April 18, 2018

RE: Heritage Trails Subdivision
Drainage Report Stamp Date: 3/15/18
Drainage Report Supplement Stamp Date: 4/13/18
Grading Plan Stamp Date: 4/13/18
Hydrology File: N08D006F

Based on the information provided on 4/13/18 and previous submittals, the Drainage Report, Drainage Report Supplement, and Grading Plan are approved for Preliminary Plat and Grading Permit.

Based on the information provided in your submittal received on 3/30/18, the Drainage Report and Grading Plan cannot be approved for Preliminary Plat or Grading Permit until the following are corrected and a revised Drainage Report and Grading Plan are submitted.

SECTION F - POND DETAIL
(SCALE: 1"=10')

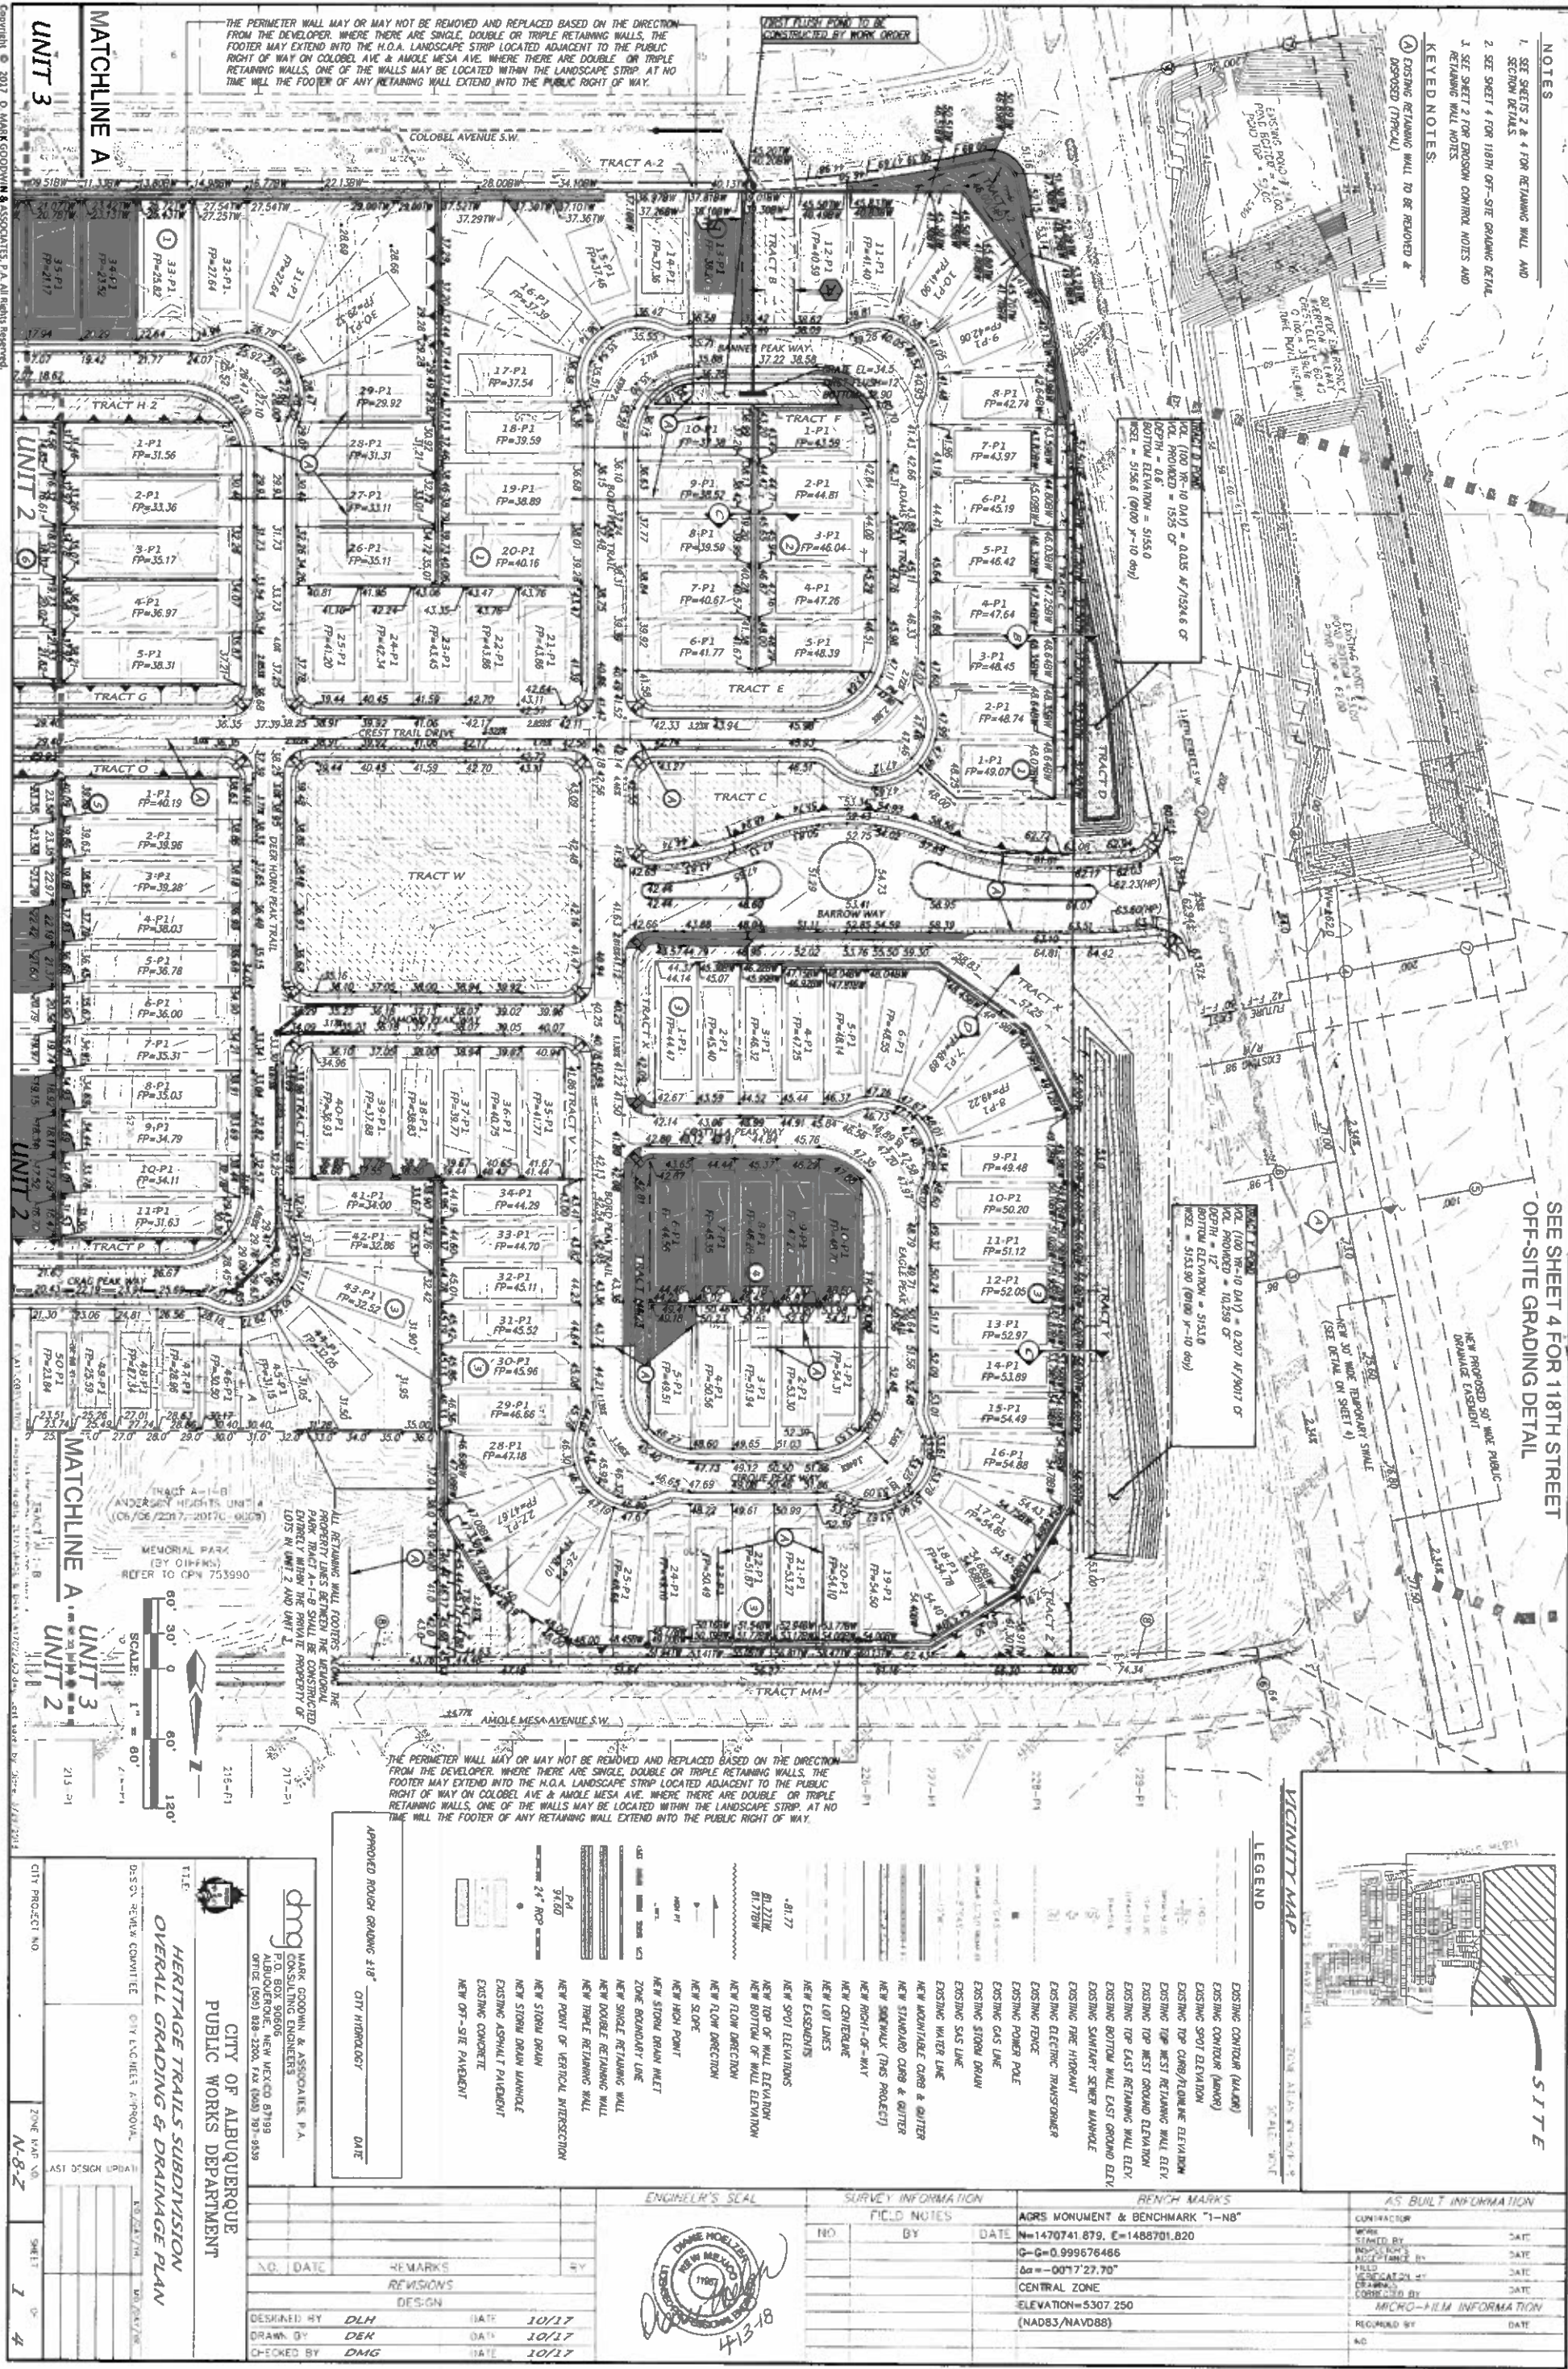
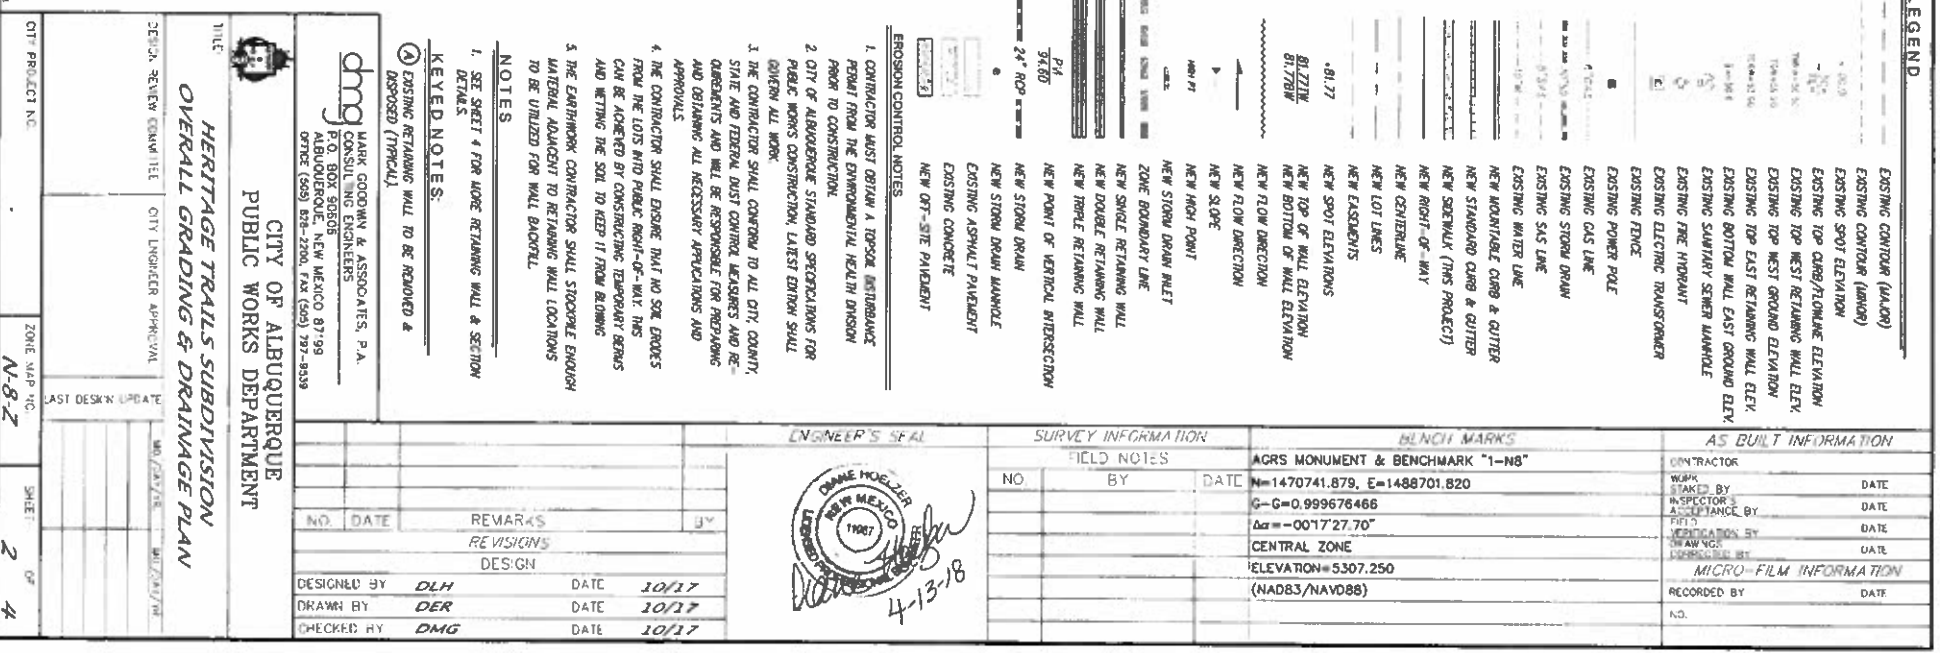
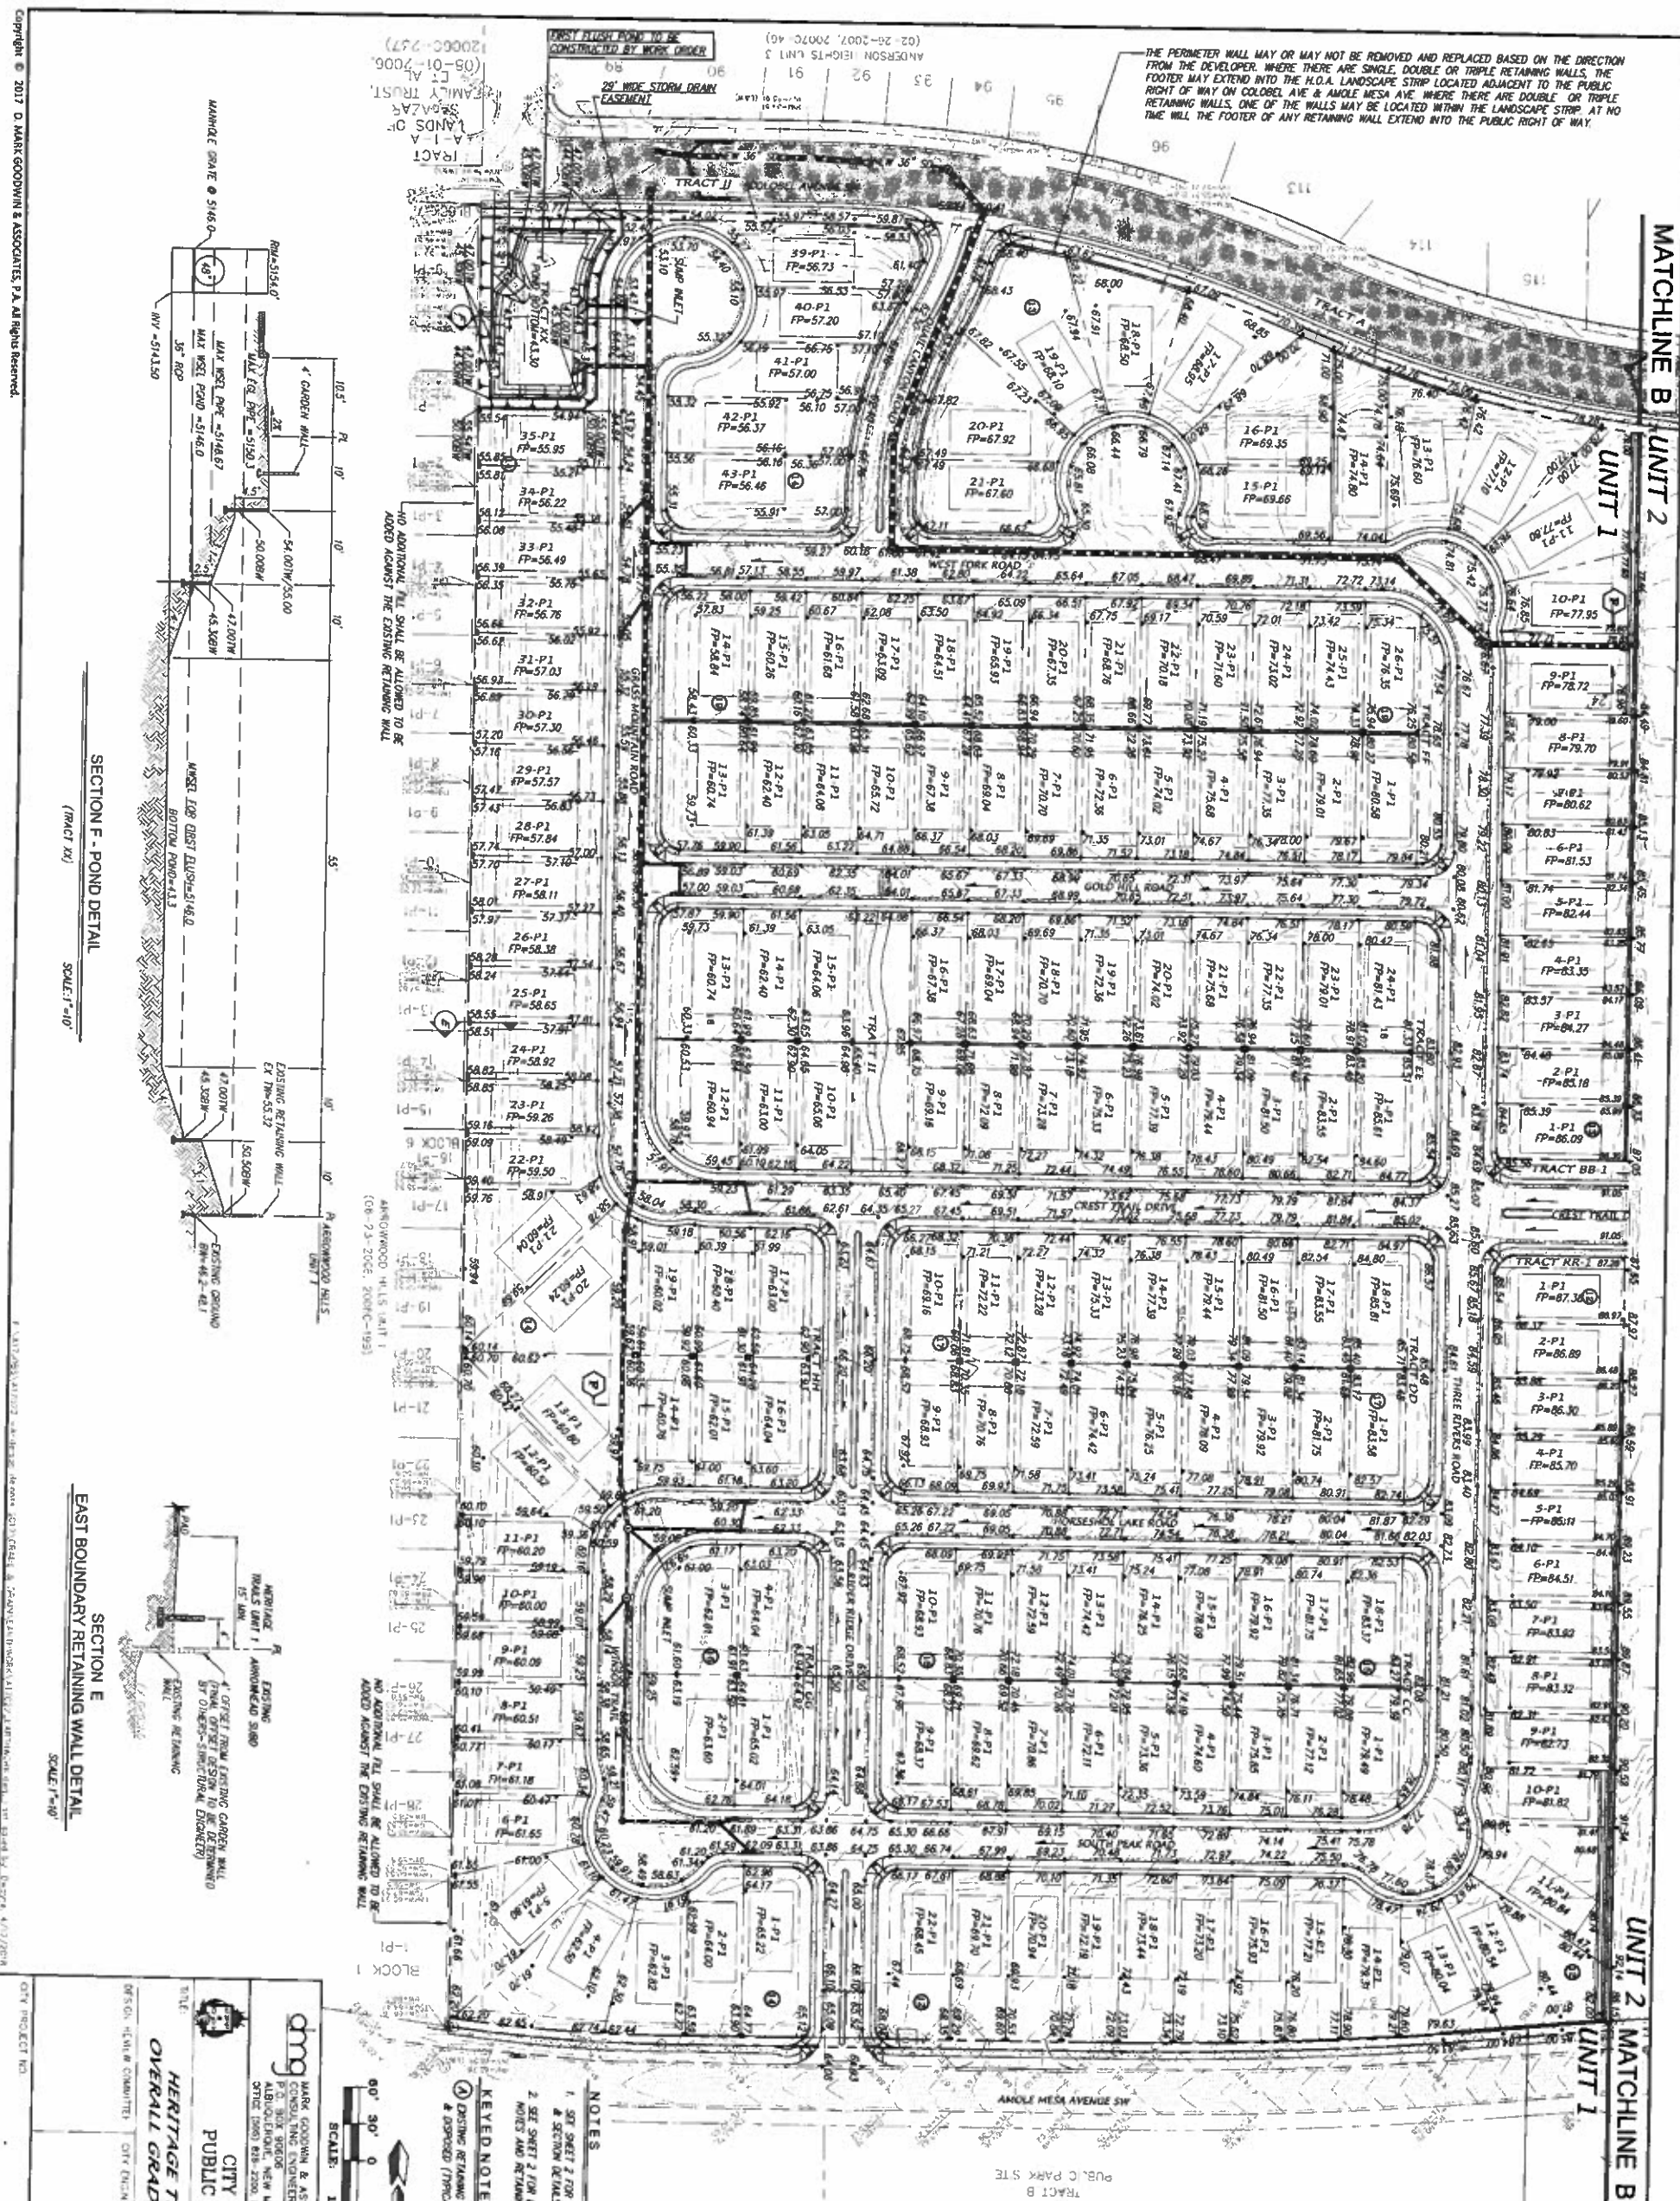
13. Clarify Section E-E (the wall section along the boundary with Arrowhead Subdivision) to show that no new fill is being placed against the existing wall. Show and label the existing vs. proposed grades (typ.) and add a note that "no additional fill is to be placed against the existing wall".
